MEADOWSWEET PROPERTY

PROJECT DESCRIPTION: Prior Approvals

DISCUSSION OF ISSUES

| <p>OWNER: MEADOWSWEET 1000 ANDERSON DRIVE SUITE 201 BOSTON, MA 02128 CONTACT: STEVE CONKLE</p> | <p>MEADOWSWEET PROPERTY IMPERVIOUSNESS EXHIBITS</p> | <p>MEADOWSWEET LORRA SULLIVAN ELECTRICAL DISTRICT COUNTY, STATE</p> | <p>MEASUREMENTS DATE: 10/11/08 SCALE: 1"=40'</p> |

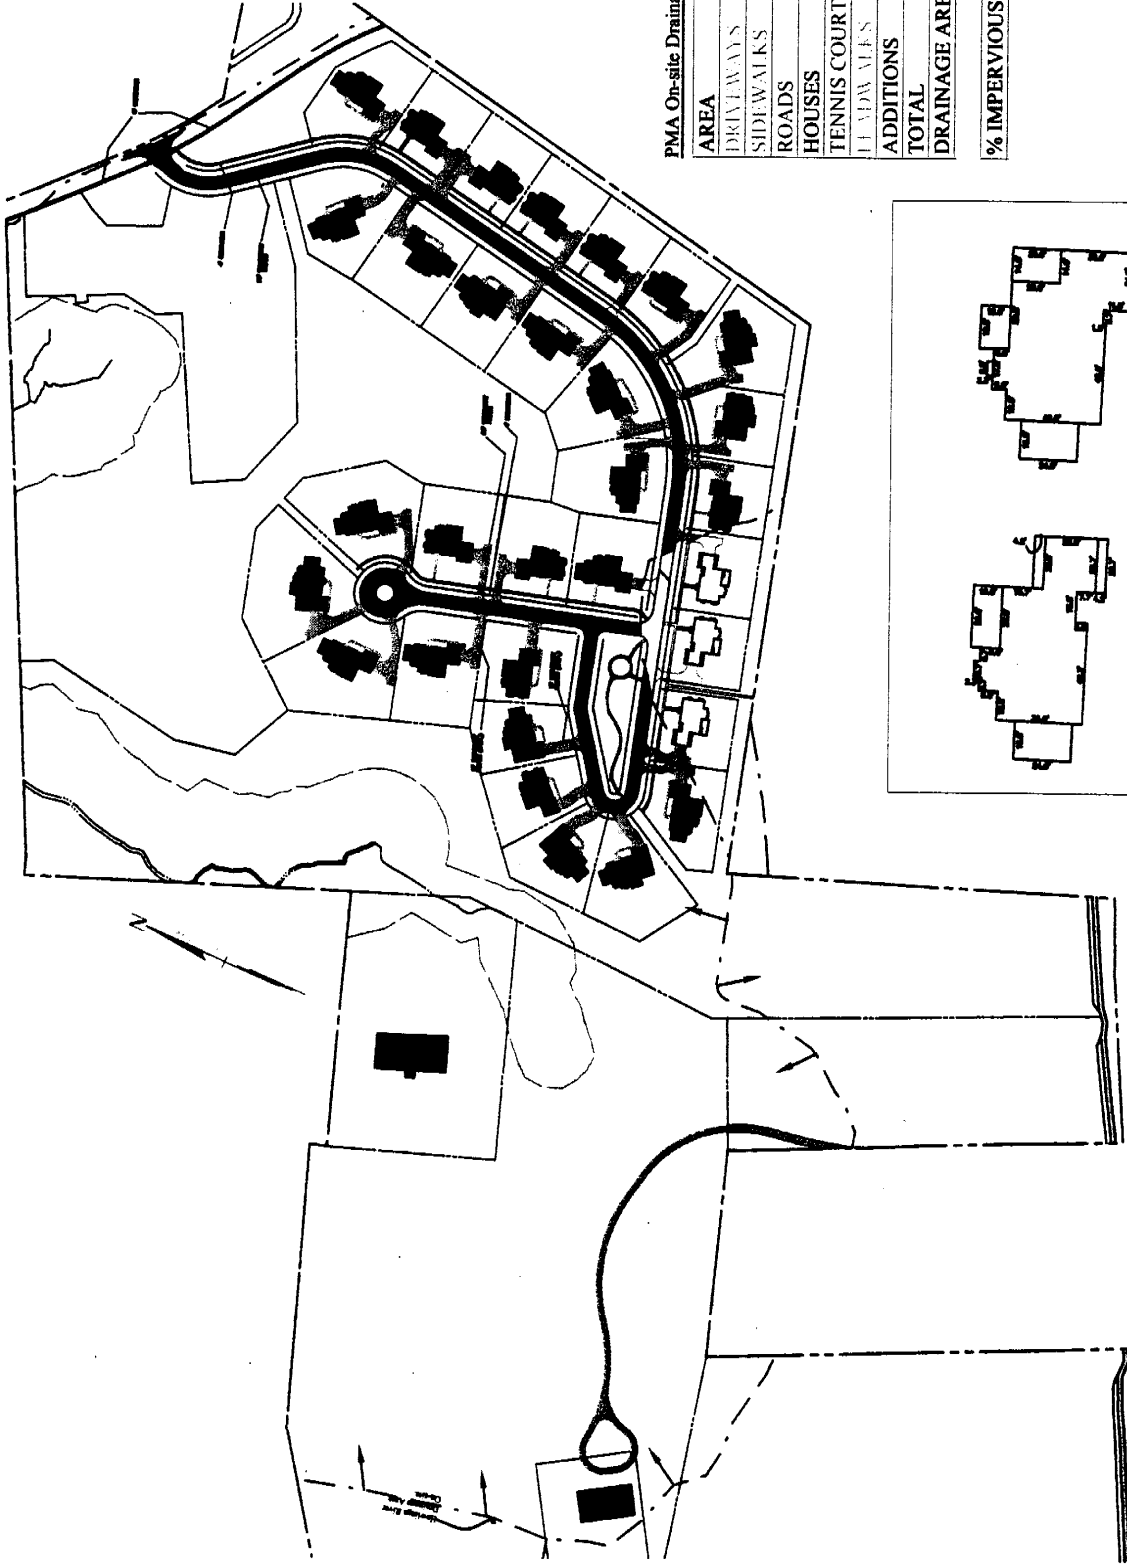
Sidewalks within the community are provided on the south side of Meadowsweet Drive and on the east side of Meadowsweet Court. A waiver to sidewalks on both sides of a public road has been requested by the applicant due to impervious restrictions within the Patuxent Primary Management Area (PMA). A five-foot wide sidewalk will also be provided by the applicant from Meadowsweet Drive to the Board of Education property line, between lots 11 and 12.

Vehicular circulation is safe and efficient and consists of a reduced width tertiary public road with twenty-six feet of paving to minimize impervious coverage in the PMA. A waiver has been requested by the applicant and supported by staff for the reduced width tertiary road and modifications to the cul-de-sac.

EQUESTRIAN TRAIL EXHIBIT

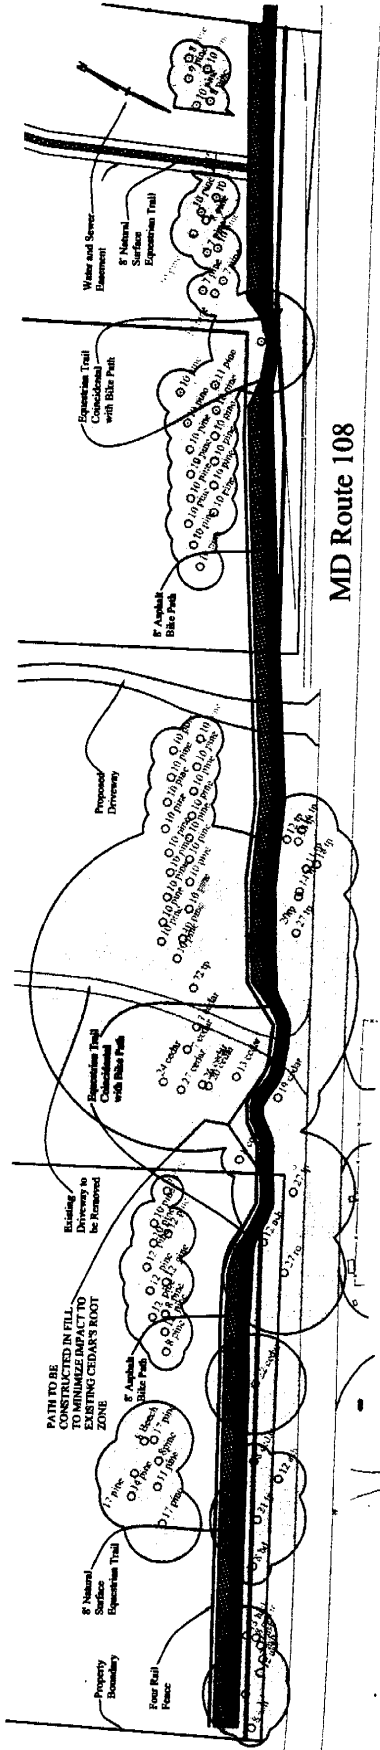
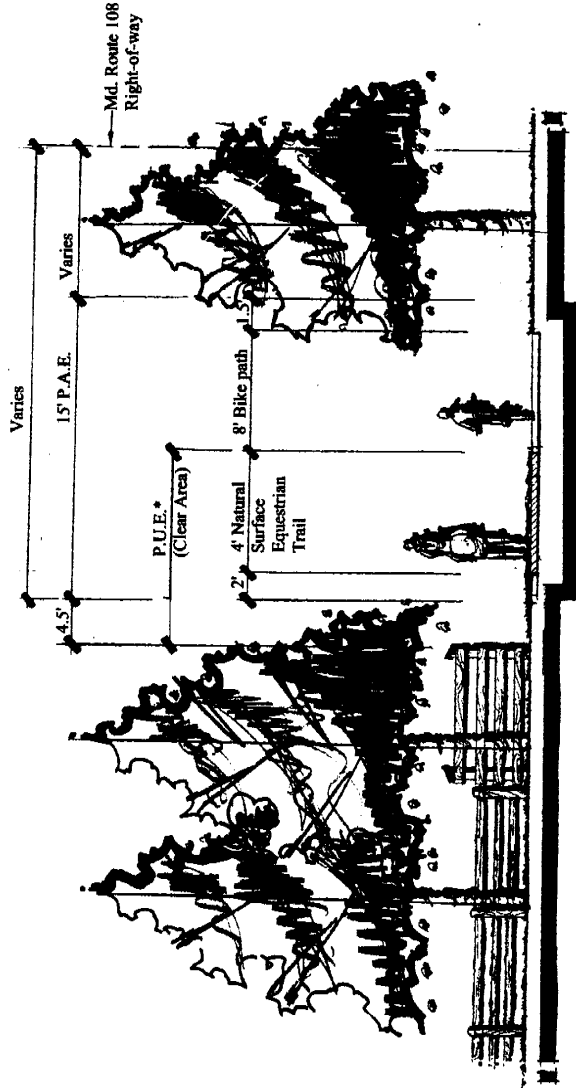
A four-foot wide equestrian trail easement and natural trail within a 15-foot Public Access Easement (PAE) will be provided by the applicant through Rural Open Space-Parcels D and E, from Meadowsweet Drive to MD 108 and connecting to the existing trail to the north adjacent to the Brook Grove Foundation (Lot 2). This trail will provide a connection from MD 108 on the west side of Sherwood Elementary School to the northern property line, and connecting with the trail that follows the wetland buffer from Brook Road to the northwest boundary of Parcel 119. The trails will assist in providing future connections to the Bancroft property and Rural Legacy Trail systems to the south and Sandy Spring properties and developments to the east of the site. The trail connection to the northwest corner of Parcel 119 will connect with existing trails through the Brook Grove property to Dr. Mess' property (parcel 200), where numerous equestrian activities occur.
